RPA STAFF RECOMMENDATION

Subdivision Case Number:	2015-027	PC Meeting Date: 08-10-15
Subdivision Name:	Seebeck Brittany Farm Lane Property Lots 1 and 2	
Applicant Request:	Final Plat	
Property Location:	Brittany Farm Lane (Private)	
Property Owner:	Jurgen Seebeck	
Applicant:	Richmond Surveying	
Total Acreage:	2.84 Acres	
Proposed Density:	0.70 dwelling units per acre	
Tax Map Number:	123-025	
Zoning:	A-1 Agricultural District	
Staff Recommendation:	<p>DENY</p> <p>The proposed subdivision plat does not comply with Hamilton County Subdivision Regulation, Section 402.1 Required Access for Residential Lots.</p>

FINAL PLAT
SEEBECK BRITANNY FARM LANE PROPERTY

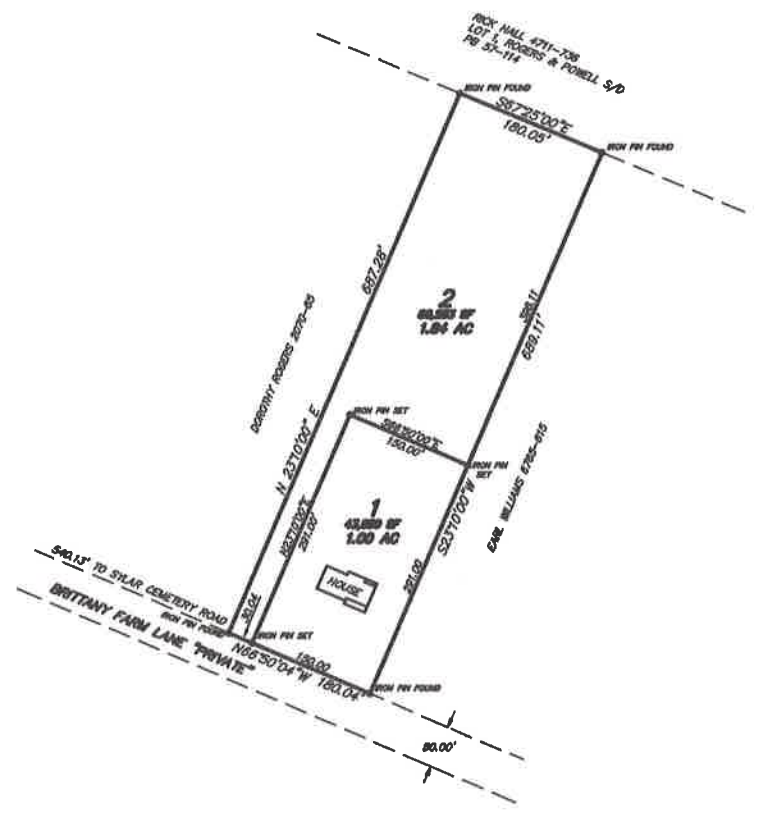
1. Section 402.1 Required Access for Residential lots requires that any lot less than five (5) acres in size shall have frontage along a county accepted and county maintained public road, or on a private road built to county standards and right-of-way standards.

Applicant has applied for a variance to Section 402.1 (See Subdivision Case 2015-026) to permit a two (2) lots with frontage along a private road/easement that are less than five (5) acres in size. Staff has recommended to deny the variance request. If the variance is approved by the Chattanooga-Hamilton County Regional Planning Commission then proposed final subdivision plat would comply with the requirements of the Hamilton County Subdivision Regulations.

1. Show street addresses for each lot. Addresses will be assigned after the Chattanooga-Hamilton County Regional Planning Commission has formally approved the final subdivision plat.
2. Contact Hamilton County GIS for approval of proposed street names.
3. Submit Geo-referenced CAD file used to create the subdivision plat to Hamilton County GIS prior to the signing of the final plat.
4. Questions concerning Hamilton County GIS comments and notes please contact GIS at (423) 209-7760.
